## **Proposal for the 09 series of amendments of UN Regulation No. 16 (Safety-belts)**

### **Submitted by the expert from Japan**

Figure 3. Relation between amount of slack of the buckle strap and dummy 3ms chest maximum acceleration

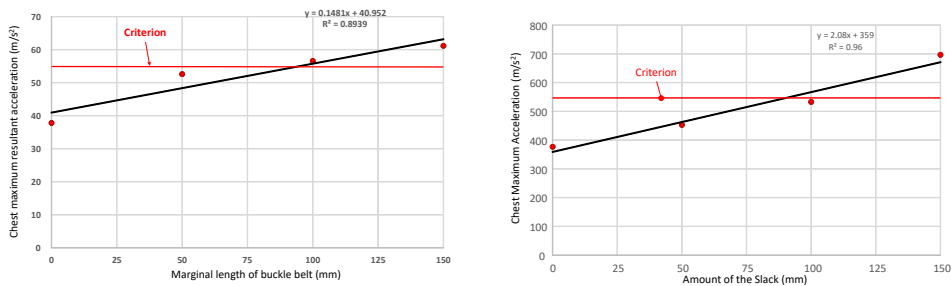
2. When the strap's paths between the effective belt anchorage and the buckle are not straight, the occupants may move forward largely during a frontal impact accident. If an occupant is seated in the booster seat attached by ISOFIX, there are cases in which the seatbelt slips up to the neck and in which submarining occurs (referred to in GRSP69-XY). These phenomena would increase the risk to the neck and abdomen of a child occupant. In addition, the dummy chest injury measures becomes increasing. Figure 3 shows the relation between the amount of slack of the buckle strap and dummy 3ms chest maximum acceleration for two types of CRS. When the slack of the buckle belt was over [50] mm, the chest maximum acceleration was near the R129 criteria in one CRS. When the slack of the buckle belt was over [80] mm, the chest maximum acceleration exceeded the R129 criteria.

- "8.2.3. The requirement of the strap between the buckle and effective belt anchorage at seats equipped with ISOFIX lower anchorages."
- "8.2.3.1. The difference between the actual strap length and the straight line distance between the effective belt anchorage and BP point for the buckle strap, according to paragraph 3.2. of Annex 17 Appendix 1, should be [50] mm or less."
